# Access Compliance Report

## Public Rights-of-Way

### (Curb Ramps)

Intersection ID: 49130	Main Street: AUBURN_HILL_LN	Cross Street: WILTSHIRE_RIDGE_RD	Location: NW
ADA ID: 94E4F540EA83	Ramp Type: Perp	Initial Pass/Fail: Fail	Overall Compliance: No
Severity Score: 10			
Codes/Mitigation Info/Possible Solution		Field Measurements/Component Compliance

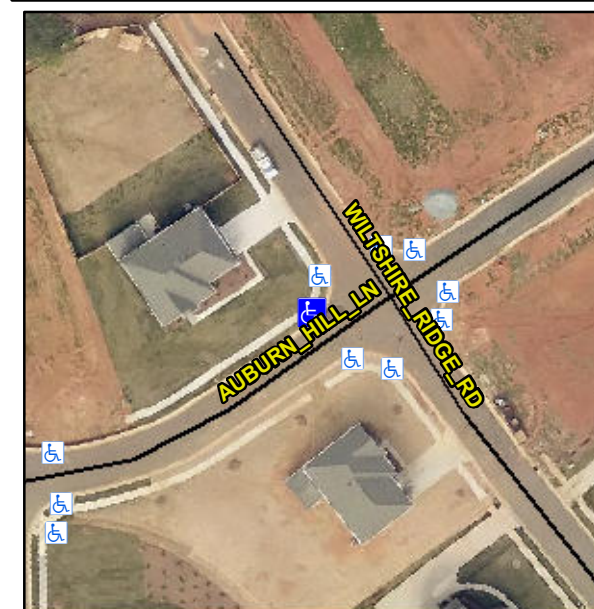
**Not Found, R304.5.1**

Compliance	Description	Data	Compliance	Description	Data
N/A	Ramp Length (in)	48.0	Yes	Ramp Slope (%)	5.0
No	Ramp Width (in)	46.0	Yes	Ramp XSlope (%)	3.3
N/A	Flare Type LT	N/A	N/A	Flare Type RT	N/A
N/A	Flare Slope LT (%)	N/A	N/A	Flare Slope RT (%)	N/A
N/A	Flare Traversable LT?	N/A	N/A	Flare Traversable RT?	N/A
N/A	Landing Length (in)	N/A	N/A	DWS Provided?	N/A
N/A	Landing Width (in)	N/A	N/A	DWS Contrast?	N/A
N/A	Landing Slope (%)	N/A	N/A	DWS Length (in)	N/A
N/A	Landing X Slope (%)	N/A	N/A	DWS Full Width?	N/A
N/A	Landing Curb? (Y/N)	N/A	N/A	DWS Offset (in)	N/A
N/A	Shared Landing?	N/A			
N/A	Gutter Ponding?	N/A	N/A	Gutter Slope (%)	N/A
N/A	Gutter Lip Ht (in)	N/A	N/A	Gutter X Slope (%)	N/A
N/A	Painted X Walk1?	No	N/A	Painted X Walk2?	N/A
	X Walk 1 Direction	To S		X Walk 2 Direction	N/A
N/A	X Walk 1 Width (in)	N/A	N/A	X Walk 2 Width (in)	N/A
	X Walk 1 Slope (%)	3.4		X Walk 2 Slope (%)	N/A
	X Walk 1 X Slope (%)	4.0		X Walk 2 X Slope (%)	N/A

**Remove & Replace Entire Ramp.**
